Contract #: 04-0120F4Cty: SF/ALA Rte: 80 PM: 13.2/13.9File #: 69.25B**QUALITY ASSURANCE -- NON-CONFORMANCE REPORT****Location:** Changxing Island, Shanghai, P.R. China**Report No:** NCR-000287**Prime Contractor:** American Bridge/Fluor Enterprises, a JV**Date:** 27-May-2009**Submitting Contractor:** Zhenhua Port Machinery Company, Ltd (ZPMC), Changxing Island**NCR #:** ZPMC-0261**Type of problem:**

Reference Description: Missed UT by QC, Weld SB003-026-061**Description of Non-Conformance:**

Job Name: SAS Superstructure

Subject: NCR No. ZPMC-0261

WELD NUMBER: SB003-026-061

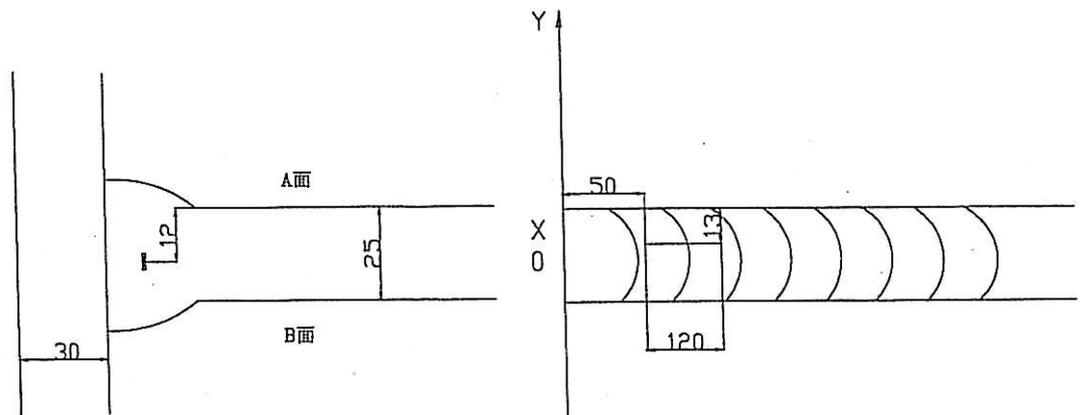
Rejected indication found by ultrasonic inspection is less than the maximum allowance aggregate length.

(UT探伤发现的缺陷总长度小于最大允许长度。)SB003-026-061

1. Gouge or grind from nearer side from metal edge ($D \leq 0.65T$, "D" is depth of defects, "T" is thickness of metal) to remove all defects;

2. Follow repair WPS for joint preparation, preheat, and weld deposit;

3. Verify with VT no defects remain in the weld joint prior to welding;

4. Grind the repaired area flush with base metal or the adjacent weld;

5. Check the welds according to the working drawings.
